City of Portland, Ma	aine - Building or Use Pe	Permit No:	Date Applied For:	CBL:			
•	101 Tel: (207) 874-8703, F		6 03-1242	10/10/2003	003 G014001		
Location of Construction:	Owner Name:		Owner Address:		Phone:		
91 Beckett St	Murray Cathleen	Murray Cathleen Z		91 Beckett St			
Business Name:	Contractor Name:			Contractor Address:			
n/a	Great East Build	Great East Builders		Box 47 Waterboro			
Lessee/Buyer's Name	Phone:	Phone:		Permit Type:			
n/a	n/a		Change of Use - Dwellings				
Proposed Use:		Propos	sed Project Description	:			
floor • expanding dorme	rs	floor	- expanding dorme	ers			
	emain a three (3) family dwelli or review and approval.	ng with the issuance	e of this permit. <b>An</b>	<b>y</b> change of use shal	l require a separate

# KATE MURRAY RESIDENCE 91 BECKETT STREET PORTLAND, MAINE

# SHED DORMER ADDITION AND EXISTING FLOOR/ROOF FRAMING REINFORCEMENT & REPAIR

TO: MIKE NUGENT CODE ENFORCEMENT OFFICER PORTLAND, MAINE

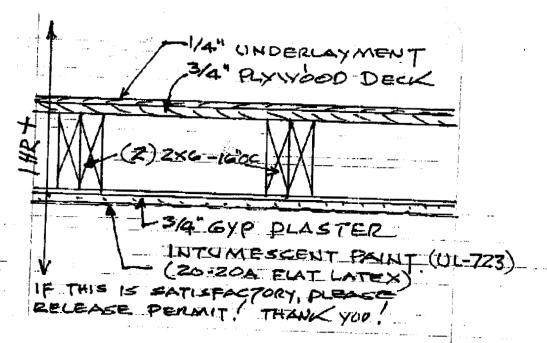
FLOOR TREATMENT - I FEEL WE HAVE A 1 HRT RATING EASILY!
